March 1, 2023

**RE:** Champion Xpress Car Wash

**Grading and Drainage Plan**

Hydrology File: K10D064

**GRADING &** DRAINAGE PLAN

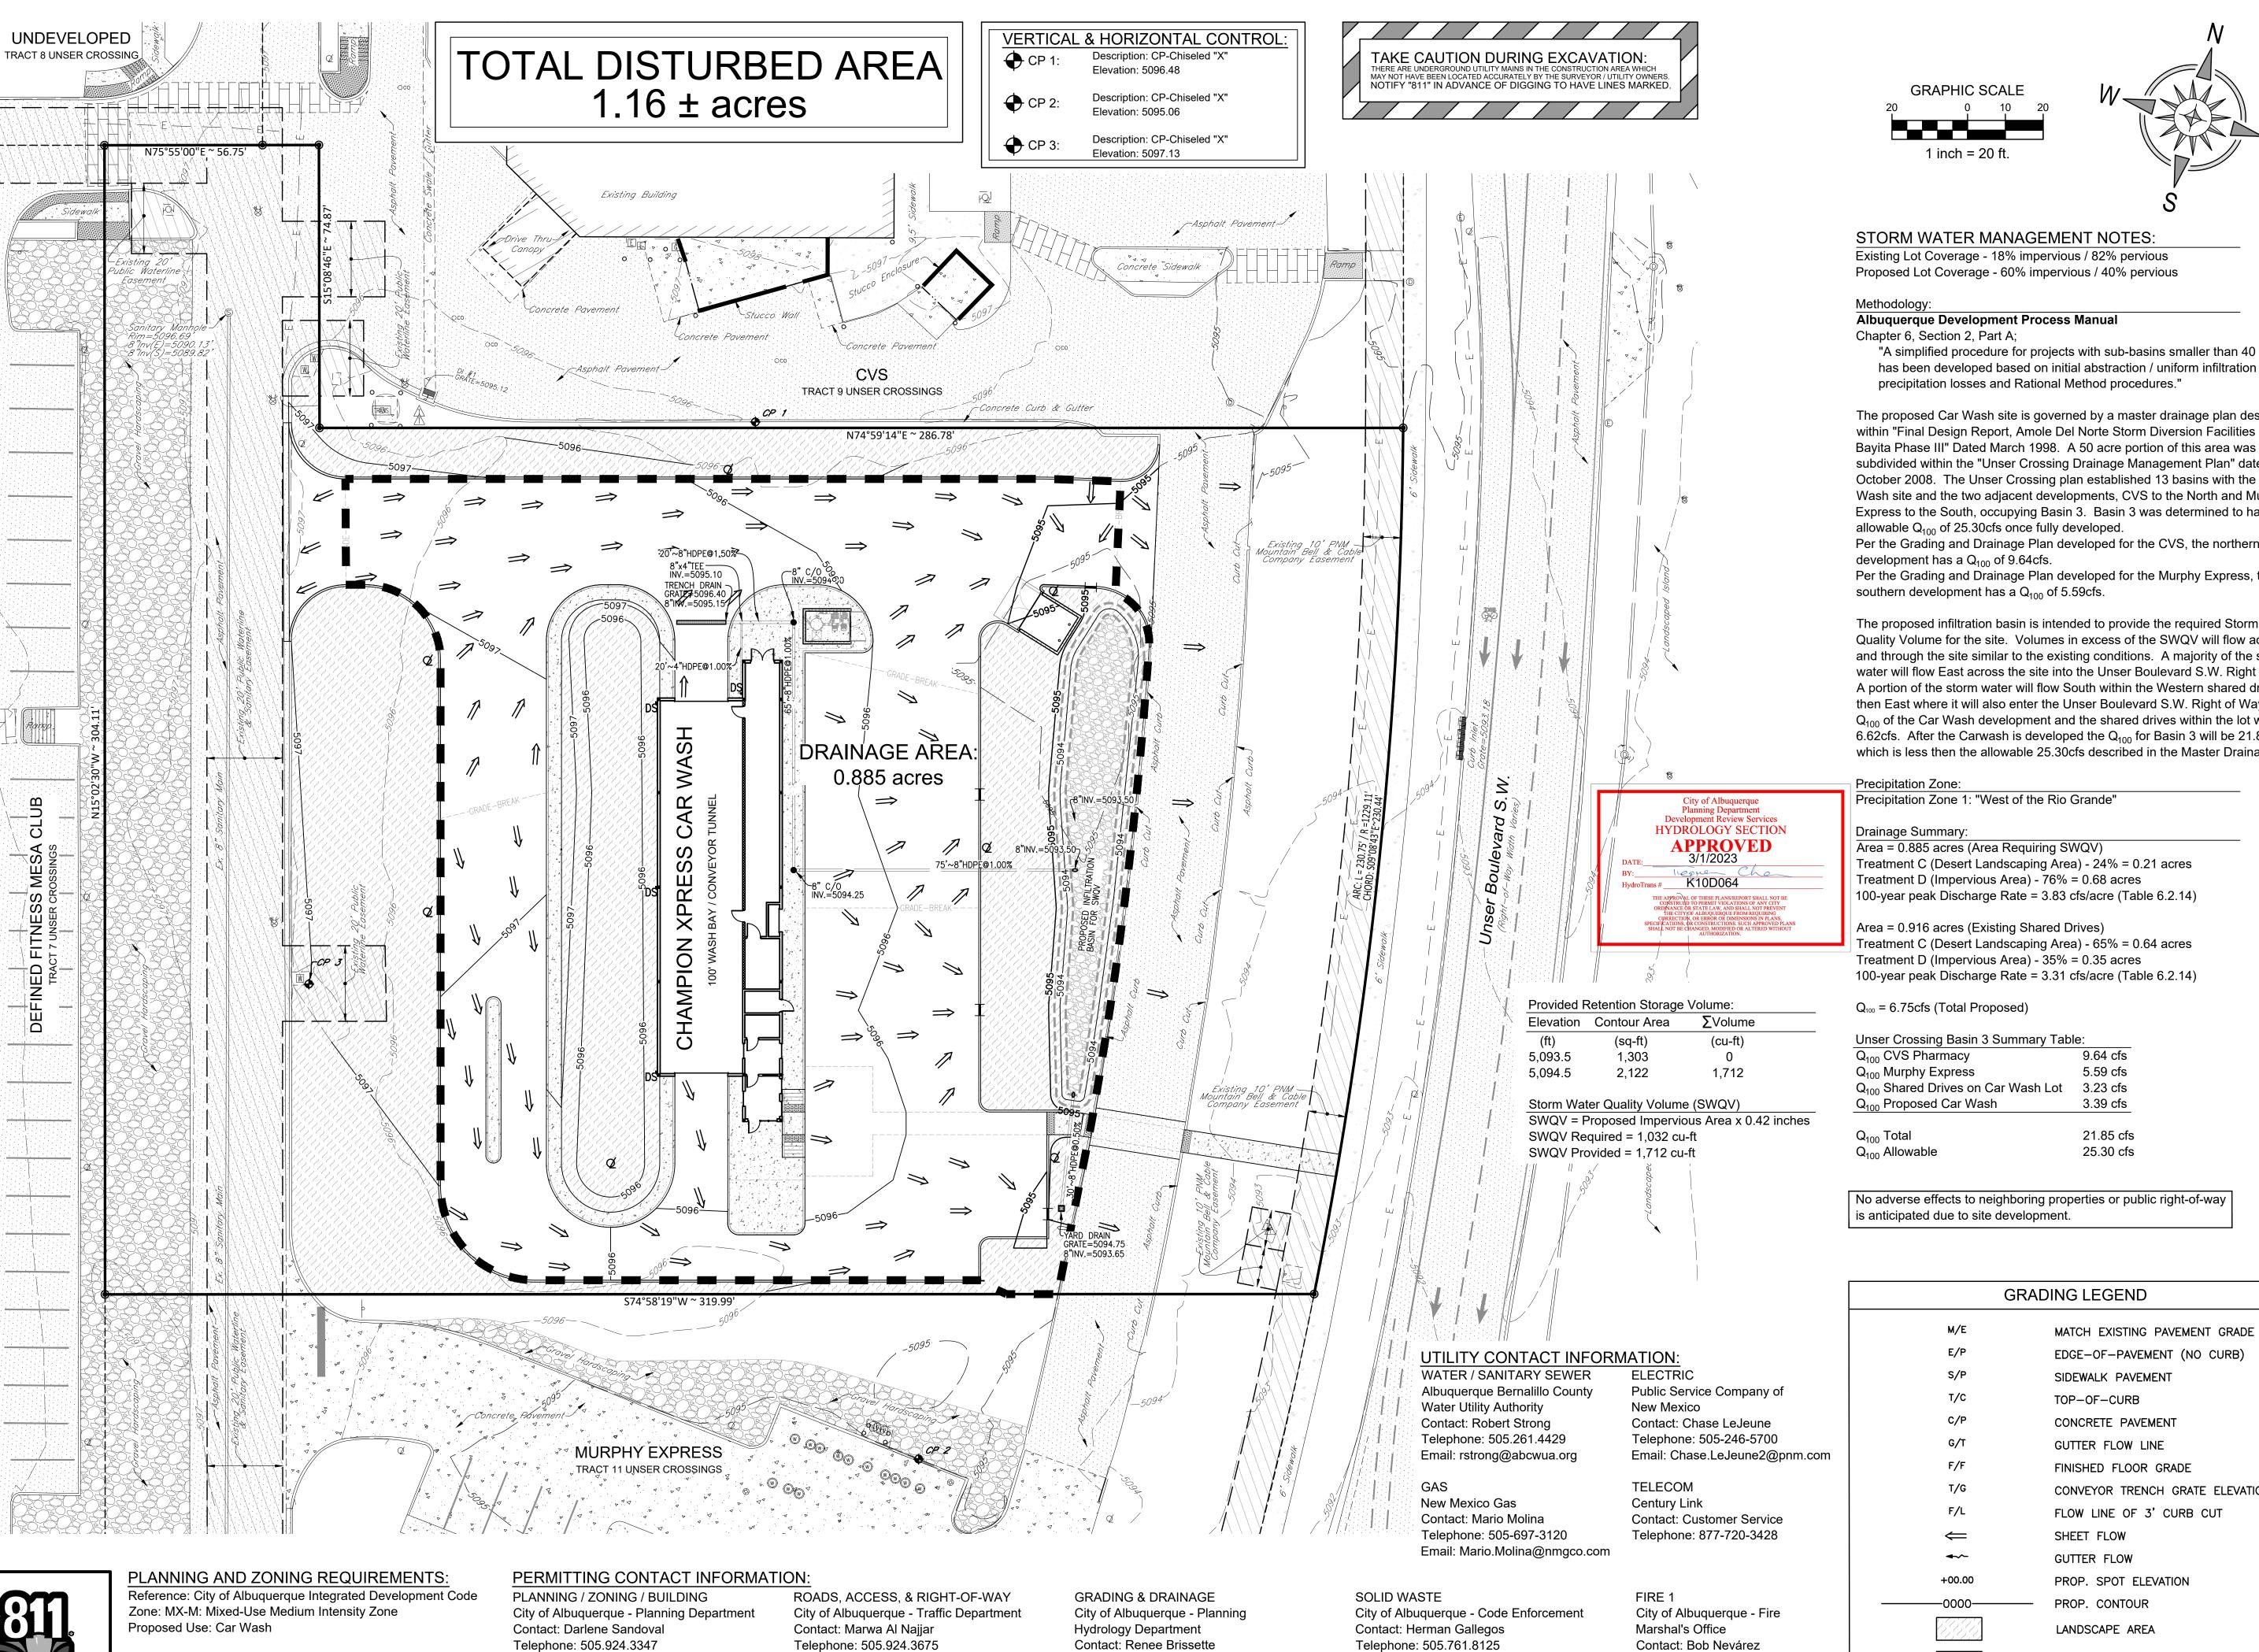
Based upon the information provided in your submittal received 2/24/2023, the Grading & Drainage Plan is approved for Building Permit approval. Please attach a copy of this approved plan in the construction sets for Building Permit processing along with a copy of this letter.

1. Engineer's Certification, per the DPM Part 6-14 (F): *Engineer's Certification Checklist For Non-Subdivision* is required.

2. Please provide the executed paper Drainage Covenant (latest revision) printed on one-side only with Exhibit A and a check for \$25 made out to "Bernalillo County" for the stormwater quality ponds per Article 6-15(C) of the DPM to Hydrology for review. Once the review is done, Hydrology will send back an email stating our approval/comments.
